**Meeting Date:** Tuesday 9 February 2016  
**Location:** Committee Room 2, Level 5, Civic Centre, 1 Devlin Street, Ryde  
**Time:** 5.00pm

- 2 490 VICTORIA RD RYDE. Lot B DP 319817. Applications pursuant to Section 96(1A) of the Environmental Planning and Assessment Act, 1979 to amend two (2) approved applications in relation to introduction of fill into the rear yard area, various retaining wall works, and increased height of approved shed.**

**Proposed Modification to Development Consent No. LDA2011/0346 under Section 96 of the Environmental Planning and Assessment Act, 1979**

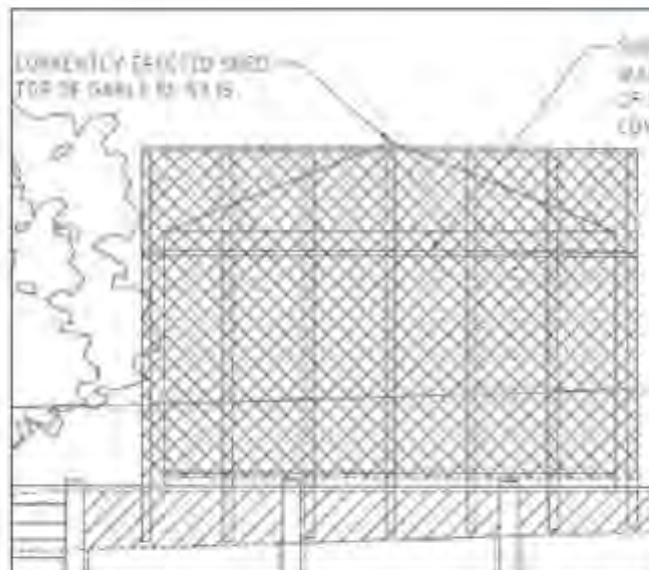
The Applicant has proposed the erection of a trellis screen behind the metal shed to improve the view of the shed from No. 7a Searle Street. This can be seen in the following plan extract:

The trellis screen can be seen to extend above the roof line of the metal shed which in turn creates additional shadow and bulk. The metal shed is light in colour which prevents attention being drawn to it as it blends with the skyline quite well in contrast to a dark colour. As such, a trellis screen would not resolve concerns relating to bulk and may in fact, contribute to any bulk caused by the shed. Subsequently, the following condition is recommended:

*1(a) The screen proposed at the rear of the shed is to be re-shaped so that it conforms to the shape of the metal shed and does not protrude beyond the shed walls or above the shed roofline. The form of screening is to allow the potential for a climbing plant to grow.*

*1(a) The screen proposed at the rear of the shed is to be re-shaped so that it conforms to the shape of the metal shed and does not protrude beyond the shed walls or above the shed roofline. The form of screening is to allow the potential for a climbing plant to grow.*
